SEWAGE DISPOSAL TESTING

MARYLAND STATE DEPARTMENT OF HEALTH

SUBDIVISION River Park Estates LOT NO. 34

October 7, 1966

Preliminary
Henry Wayfield
826 Glen Allen
Balto. 29
W.D. 5-5095
 2 lots
 3
 SKETCH PLAN
 RIVER PARK ESTATES
 THIRD ELECTION DISTRICT
 Scale: 1"=100'
 HOWARD COUNTY, MD
 October, 1963

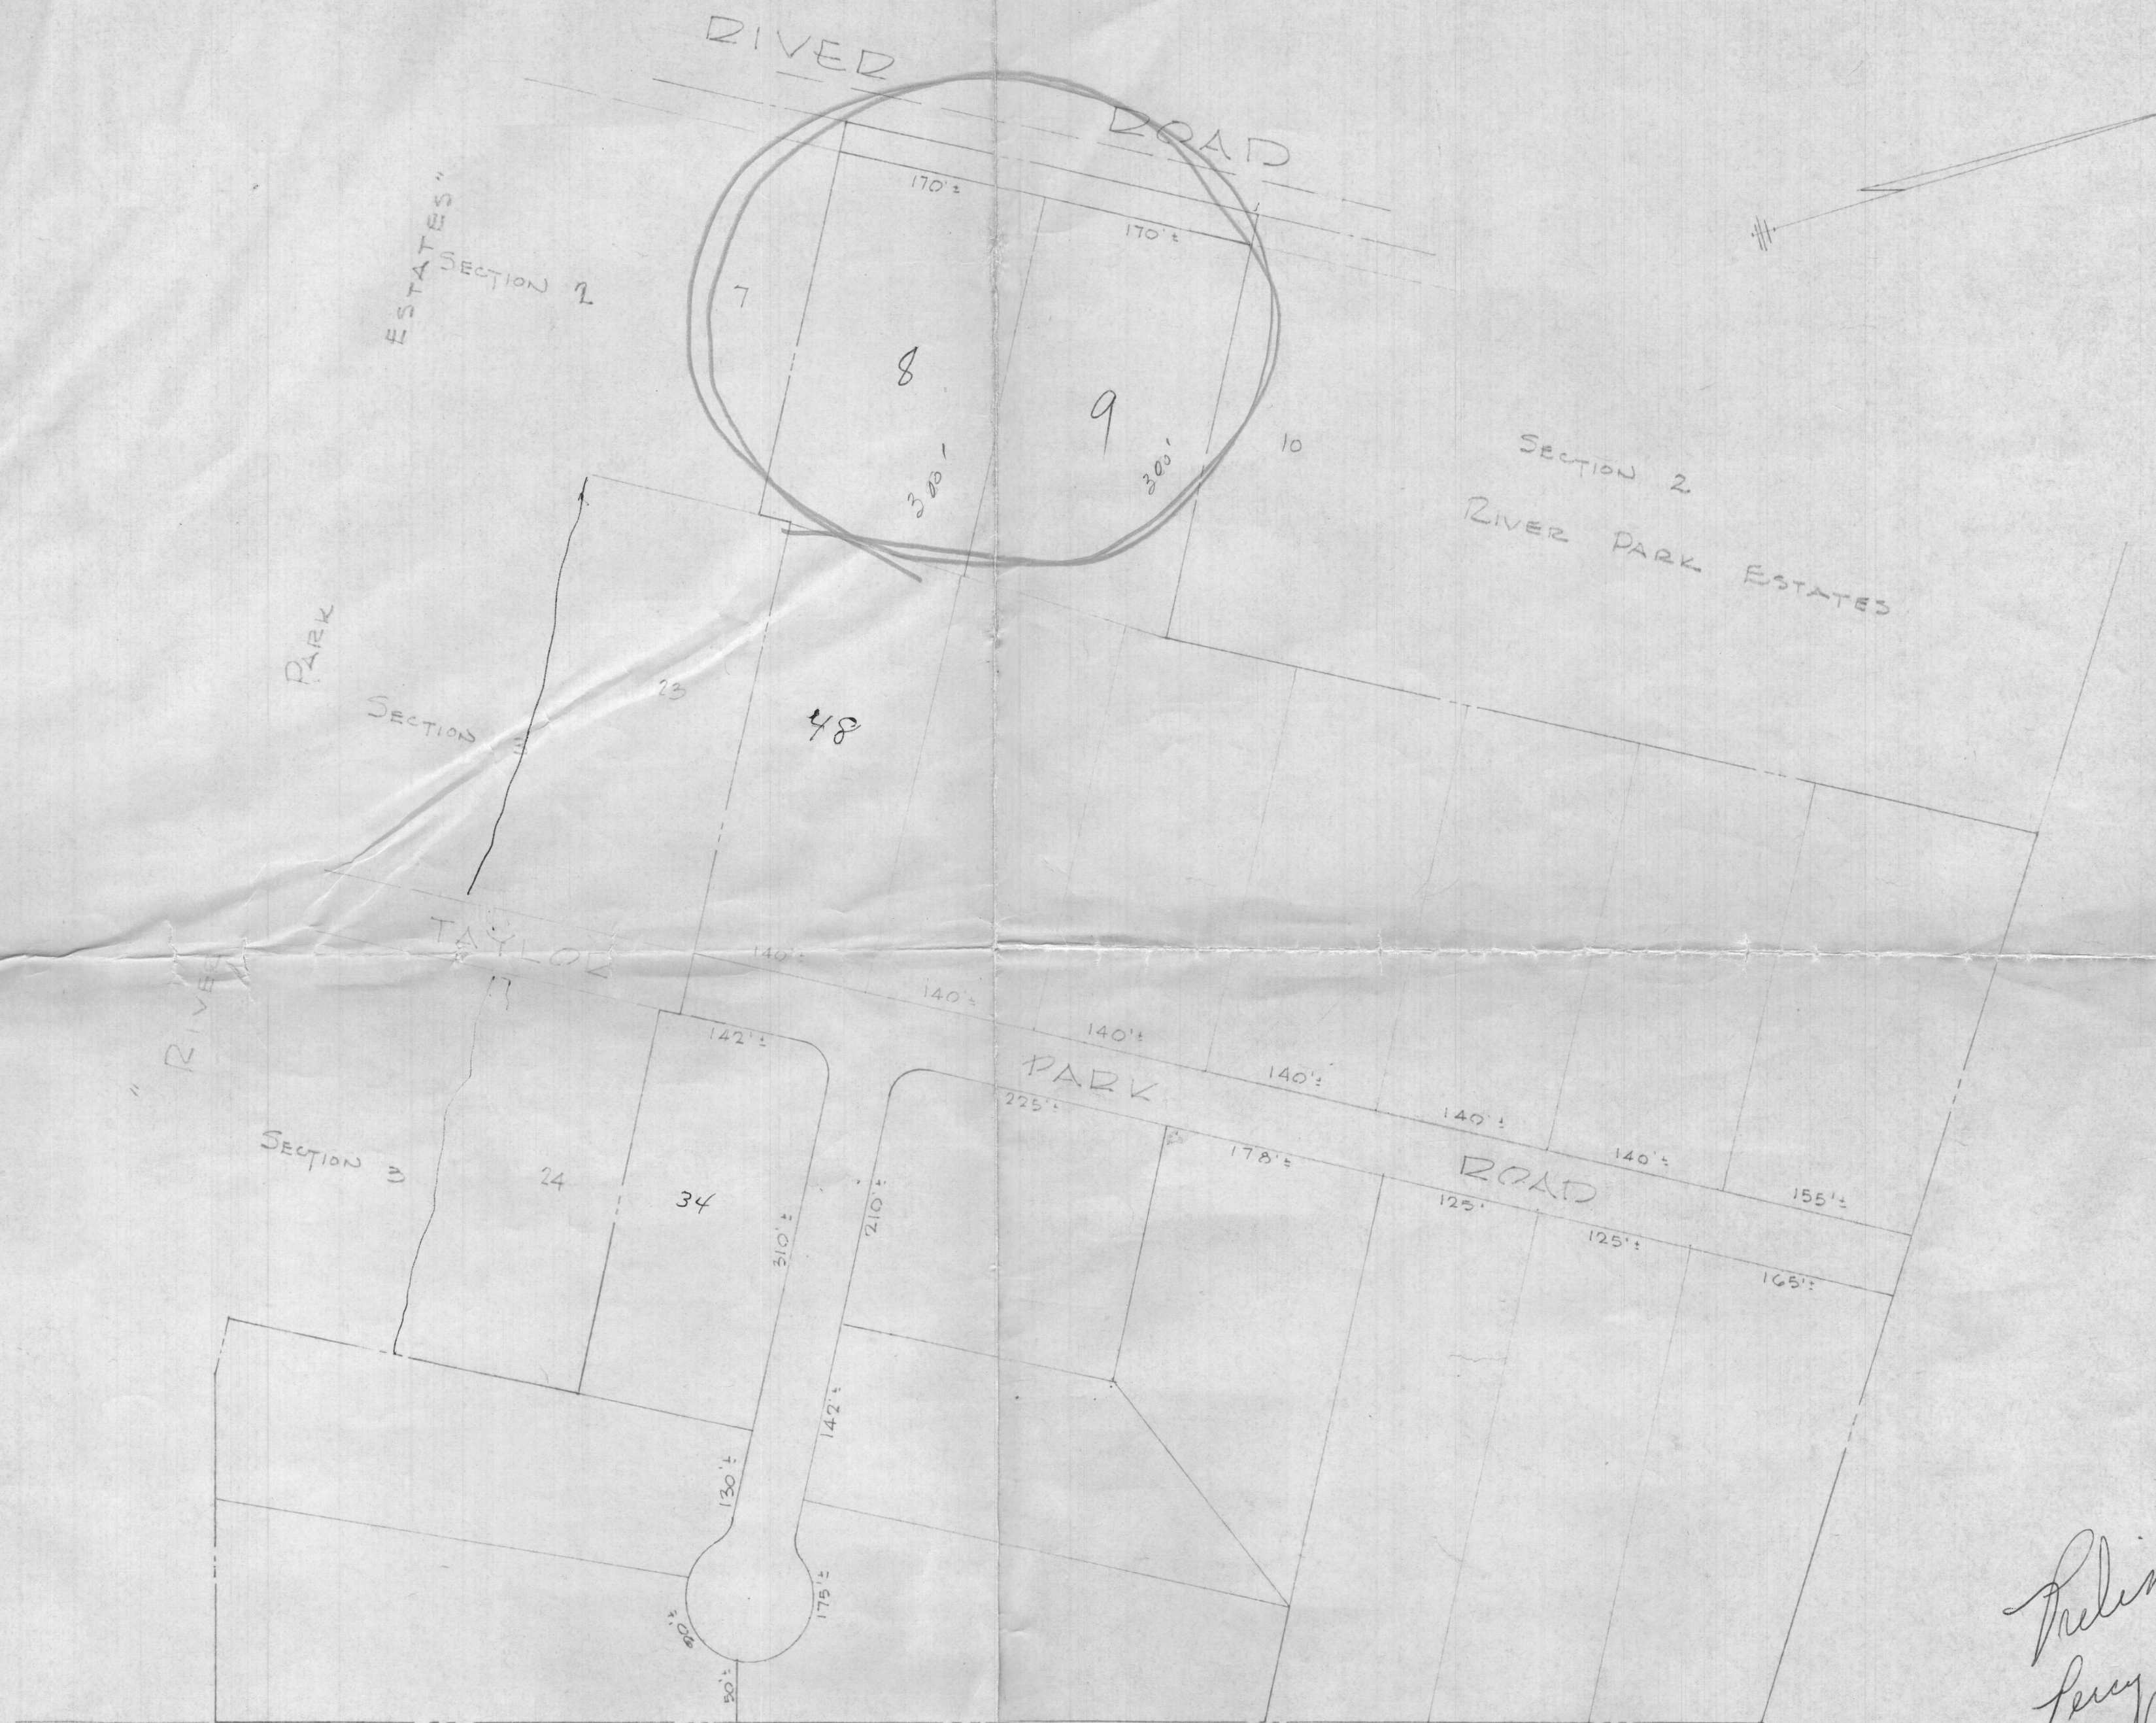
I cannot approve the final plat of River Park Estates Subdivision which was submitted to this department this week. On October 5, 1966, I inspected the property to see if there had been any changes in the sewage disposal areas as a result of rough grading. It appeared to me that the ground on Lots 39, 40 and 41 may have been cut in the sewage disposal areas. Therefore, you must prove that there is still enough porous soil on these lots for an initial sewage disposal system and a repair area.

1. Run more percolation tests on these lots; or
2. If the ground in the sewage disposal areas has not been cut excessively, you may submit a new contour map of these 3 lots showing the grade as it was before grading and as it is now.

17 OCT 66 - New Contour Map Submitted
showing new grades on Lot 39, Lot 40
& Lot 41. There had been practically no
change in the grade of the lots across Taylor
